Joint Parish Council Comments – Response Note

This Note sets out the applicant's (Oxfordshire County Council - OCC) response to the comments drafted by Charlie Hopkins Planning and Environmental Consultant dated 18th February 2022 drafted on behalf of Appleford, Sutton Courtenay, Culham, Nuneham Courtenay and Burcot & Clifton Hampden Parish Councils. Collectively the Parish Councils are referred to as the Neighbouring Parish Council Join Committee (NPC-JC).

Figure 1: Routes

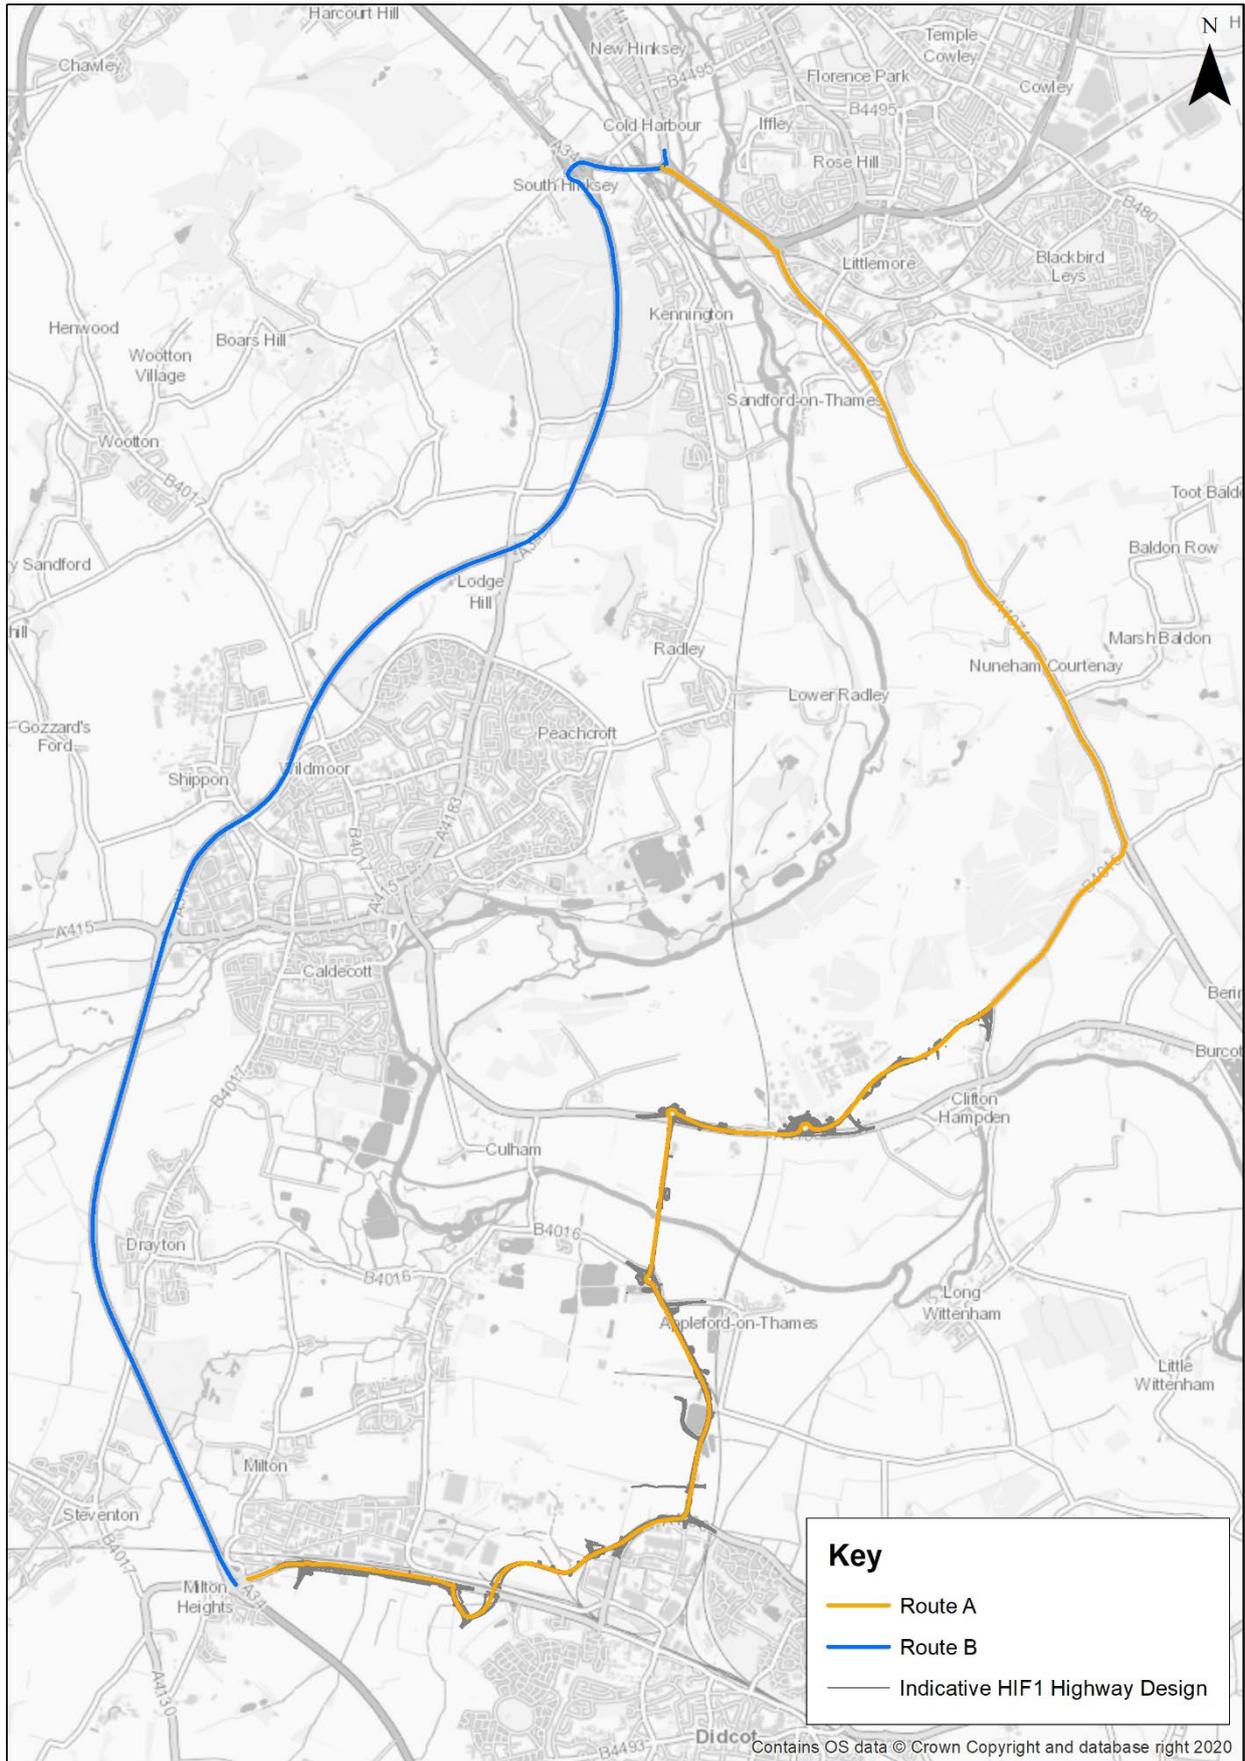
Query A: Substantial concerns arise from the reassignment of traffic from the A34 to using the upgraded HIF alignment and the subsequent impacts on the junctions into surrounding villages. Could Oxfordshire County Council confirm if junction reassignment has taken place and provide visual results of the demands along the HIF alignment in 2034?

As shown on Figure 1 Route A (Milton – HIF1 roads – A4074 via Golden Balls) is approximately 20 kilometres in length with the need to navigate 13 junctions (signals and roundabouts and roundabouts) and has sections of 30mph and 40mph roads. Compared to Route 2 (Milton Interchange – A34 – Redbridge) which is approximately 15 kilometres in length with the need to navigate 2 junctions (both signals) which for the vast majority of length is on 70mph roads.

Given the above the HIF1 Scheme is not considered to be an attractive alternative for drivers to reroute from the A34 to/from Oxford and beyond.

Figure 16.4: Selected Links for Assessment

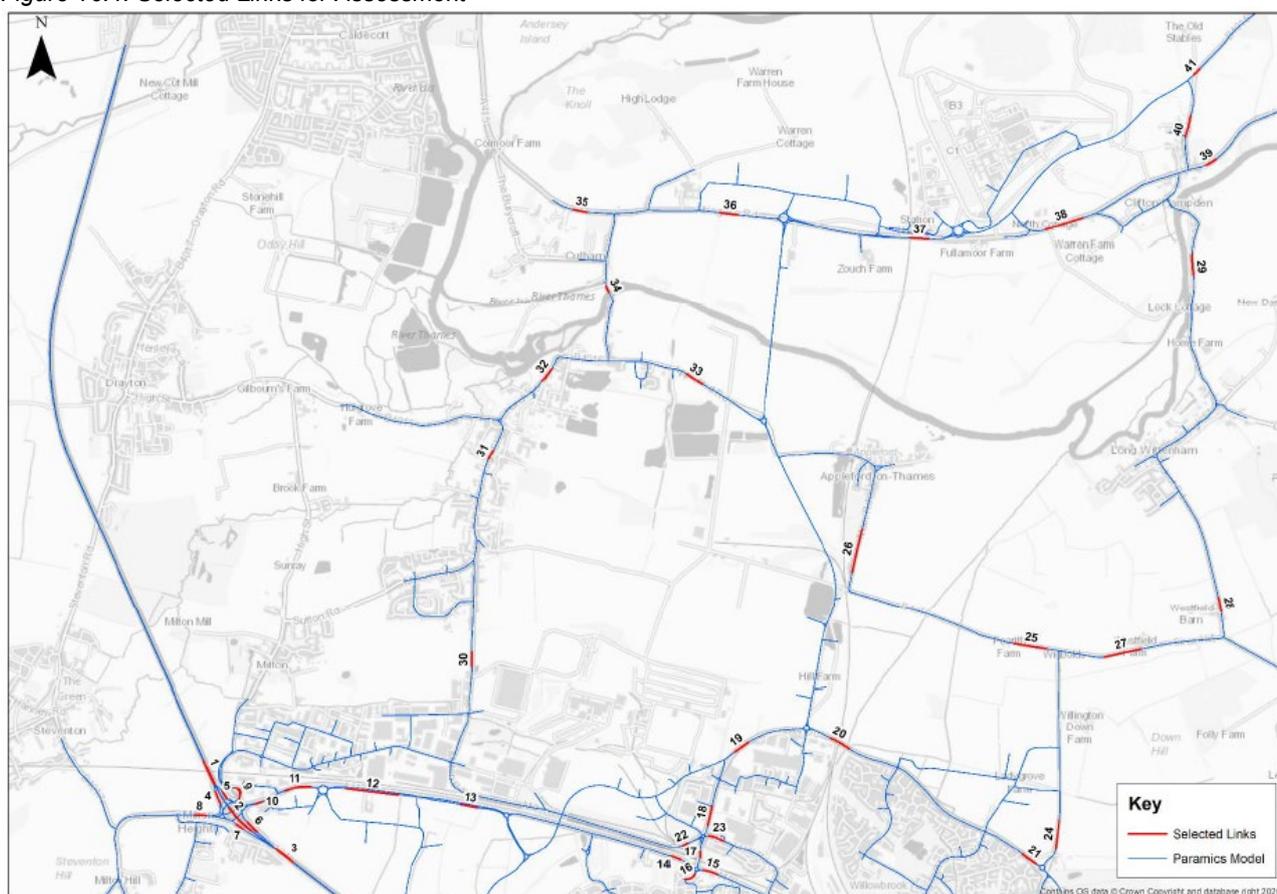
Query B: Could comparative modelling be undertaken to demonstrate the effects of traffic calming and speed restrictions on B4016 Drayton Road and Church Street through Sutton Courtenay, and B4016 Main Road Appleford when considering their links to the HIF1 proposal? In addition, could OCC comparative modelling be undertaken to evaluate the traffic density (including queue lengths) within Sutton Courtenay along the Drayton Road, High Street and Church Street; and Appleford assuming no interconnection between the B4016 and the proposed HIF1 road, to prove whether traffic will increase or decrease through Sutton Courtenay under the present proposal?

The predicted daily traffic flows with and without the HIF1 scheme is set out in Table 16.4: 2034 Daily Two-way Traffic Flows of Chapter 16 Transport of the submitted Environmental Statement. For ease the relevant links through the surrounding Villages have been highlighted overleaf and the selected road links locations has also been extracted from Figure 16.4 of Chapter 16 Transport.

As highlighted traffic restrictions in local villages are outside of the HIF1 scheme scope and therefore have not been modelled. As demonstrated the HIF1 scheme is predicted to significantly reduce daily and peak hour traffic in Appleford, Burcot, Clifton Hampden, Culham, Long Wittenham and Sutton Courtenay. If traffic calming was implemented in the future this may further reduce the attractiveness of these routes. But this will need to be considered when or if these traffic calming measures come forward.

Figure 6.17: Culham Crossing Queue Comparison (Northbound)

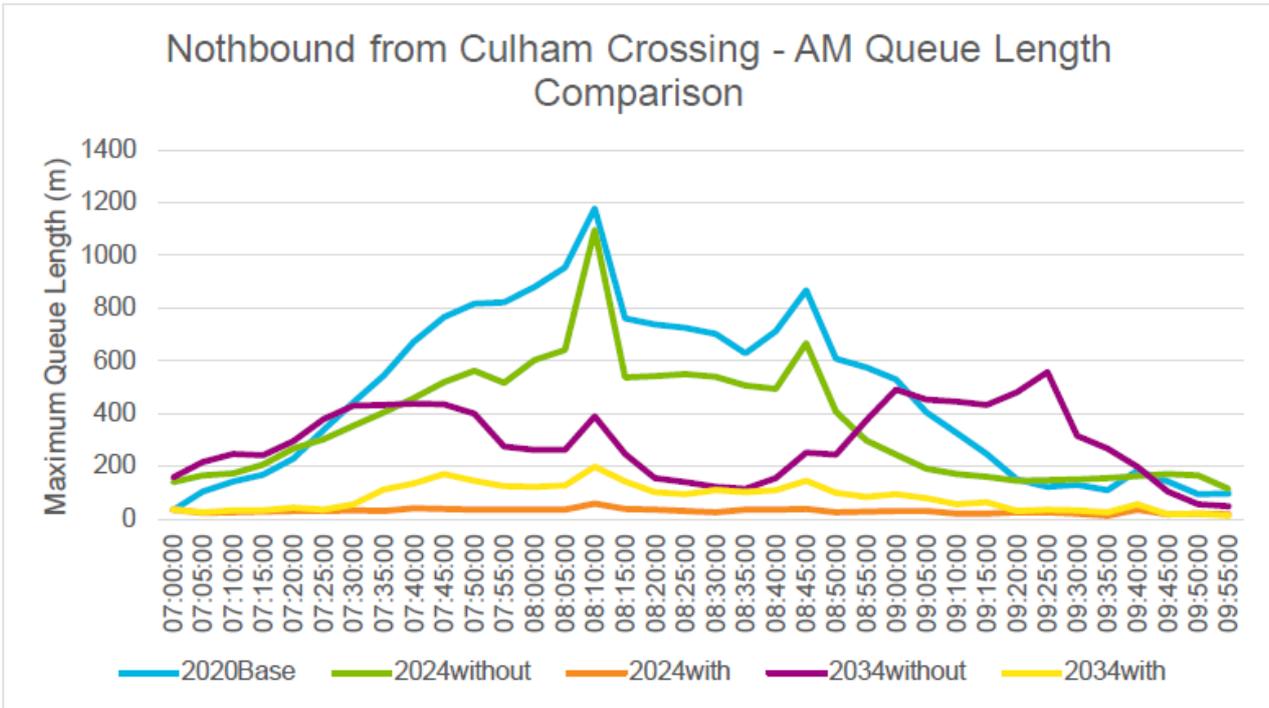
- **Rush hour density on the B4016 passing through Sutton Courtenay, including identifying traffic separately from the Drayton Road and the High Street directions.**

6.8.30 Figure 6.17 above shows that the Paramics model indicates significant reductions in queue length from the northbound signals before the bridge as a result of the HIF1 Scheme in both 2024 and 2034 AM scenarios. There is no predicted queuing from the crossing signals that would block back to the southern Appleford Road / Abingdon Road priority junction (approximately 290m distance). This contrasts to the base, 2024 without HIF and 2034 without HIF where queuing is predicted to extend back to the junction (and further through Sutton Courtenay) for large portions of the AM peak. It should be noted that the shorter queue lengths in 2024 and 2034 without HIF when compared to base are not due to an improved performance at this junction, but are a result of vehicles being stuck in queues elsewhere in the model network preventing them from reaching the junction. Regardless of this, the model shows a significant improvement at this junction as a result of the HIF1 Scheme.
